## PLANNING REPORT

# Architectural Review Board

## 83 S. Riverview Street 25-070 MPR

Address	83 S. Riverview Street, Dublin, Ohio, 43017
Proposal	Request for review and approval of a house addition on a .25-acre lot in the Historic District.
Request	Review and approval for Minor Project Review (MPR) under the provisions of Zoning Code Section 153.176.
Zoning	HD-HR, Historic Residential District
Planning Recommendation	<b><u>Approval of Waiver</u></b> <b><u>Approval of MPR with conditions</u></b>
Next Steps	Upon approval of the Waiver and MPR, the applicant may apply for building permits through Building Standards.
Applicant	Geoffrey and Melissa Hahm, Owners Kara McCoy, Simplified Living Architecture + Design
Case Manager	Sarah Tresouthick Holt, AICP, ASLA, Senior Planner (614) 410-4662 <a href="mailto:sholt@dublin.oh.us">sholt@dublin.oh.us</a>

Site Plan

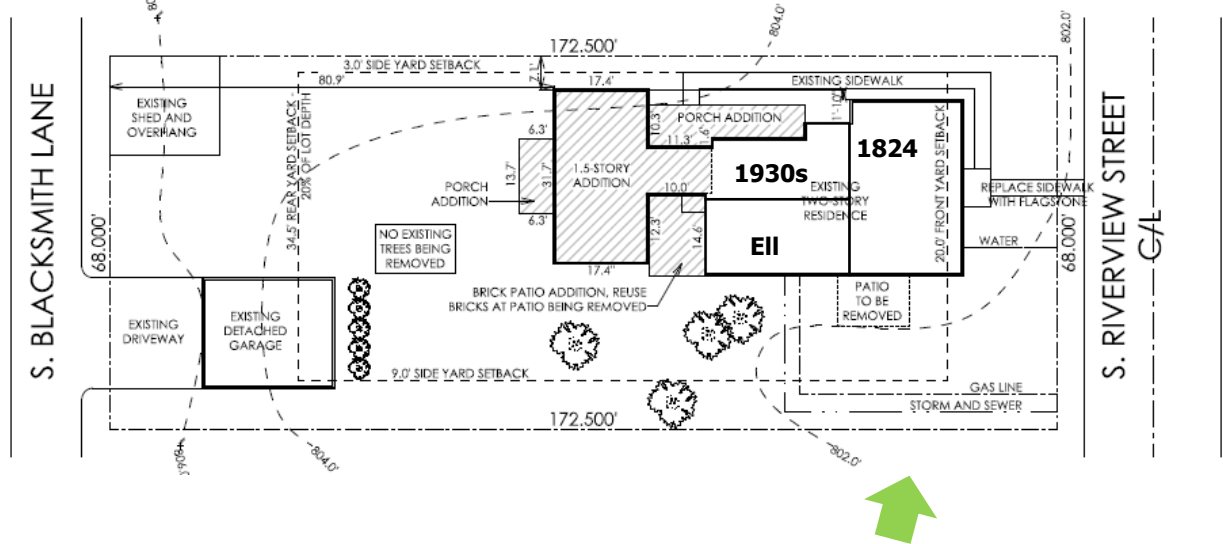
- Two options presented (Base Option was preferred; see herein).
- Waiver sought for building footprint.

### *East Elevation/S. Riverview Street*

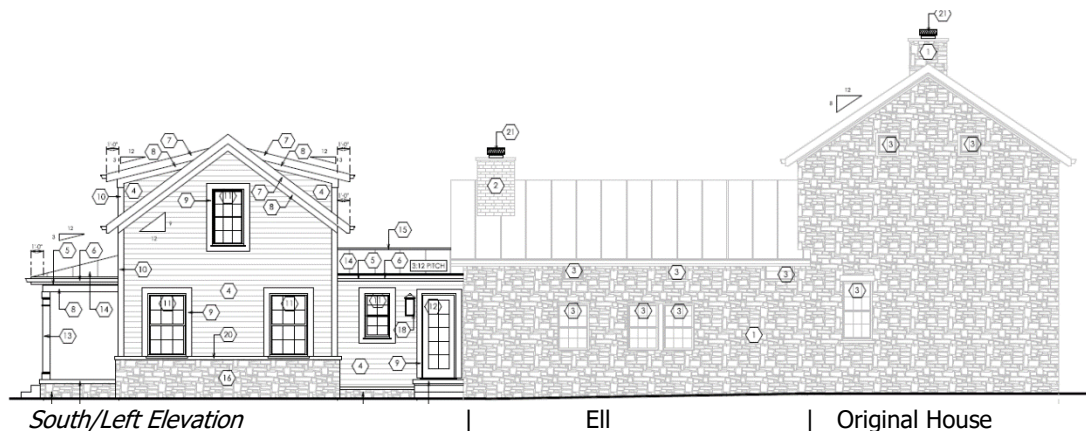
No changes to this main front façade are proposed other than window replacements. This was newly confirmed, and elevation notes should be added indicating:

- Replacement windows are necessary per Guidelines 4.8B. Staff suspects this is the case, as many appear to have been past replacements inconsistent with the structure's architectural style.
- Window replacements will be exact to current openings, per Guidelines 4.8C.
- The existing trim size and details will be maintained or replicated.
- Window sashes are suggested to be a darker color to help create shadow/depth for these features. Darker window and door colors are noted in the Pre-Approved Historic Paint Colors as features of buildings from this era of construction.

### *North/Right Elevation*

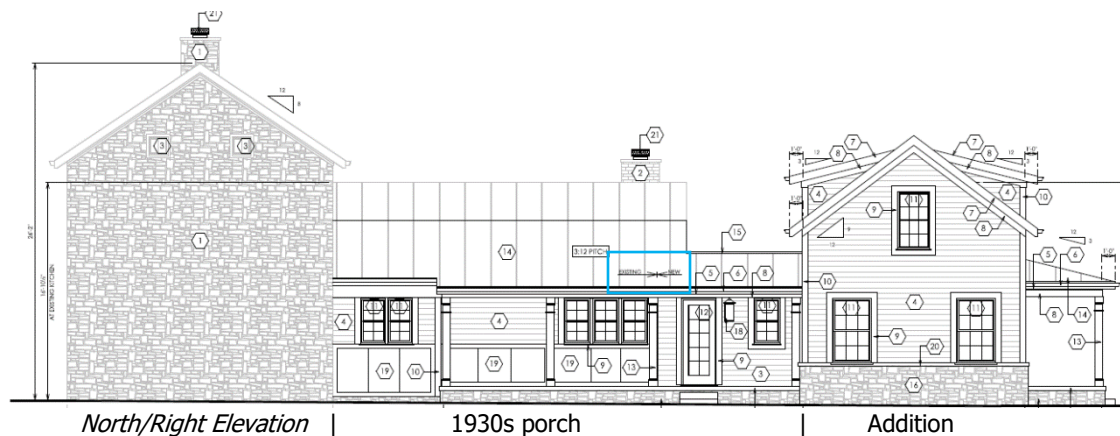
This elevation contains the 1930s addition, which is being converted into a hallway and kitchen space with a new porch added. A new 3:12 shed roof above the addition and porch, meeting Code § 153.174(B)(4)(c)(3) for roof pitch, joins the roof of the original kitchen ell, but still may cover more historic fabric than is necessary. This section of the building has groupings of windows with paneling underneath and horizontal siding in between. The roof extends above a recessed hyphen that has an exterior door and window. The side of the new addition is visible, along with the rear porch on the far right.

- Flatten 1930s addition roof form if possible to minimize impacts on historic fabric; Waiver supported. Hyphen roof might then be further flattened.

- Shorten length of new roof on the 1930s addition to differentiate from that of historic ell (see annotation showing historic vs new roof lines in blue box below).

- Center three-window grouping between columns.
- Use classical column detail (Bokor report) or square classical column mirroring ghosted remnants of 1930s columns. Provide architrave details. Use classical column spacing: columns closer together than their height (vertical openings).

- Refine "enclosed porch" paneling design; details needed.
- Use more windows/doors (potentially a centered door flanked by two windows) in center hyphen.

- Consider honoring 1930s addition more: keep window proportions, column locations, and heavy frieze detail where possible.
- Consider making a three-window grouping out of the paired windows on the left for greater consistency and coordination with the panels below. Interior programming seems to permit this.

*West Elevation*

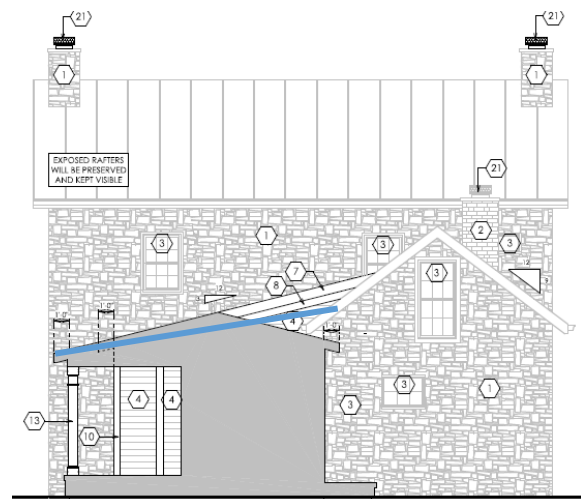
The west elevation, shows the 1 ½ story addition and porch facing the alley. The design now includes vertical windows in the upper story shed roof dormer, and windows are arranged symmetrically, per Code § 153.174(D)(5). The porch is a portico form, with a preferred 3:1 roof pitch. The water table and cap were brought up under the windows as requested.

- Lower story window proportions are not historic.
- Column details need to be revised.
- Span of porch is longer than column height: add two more columns.
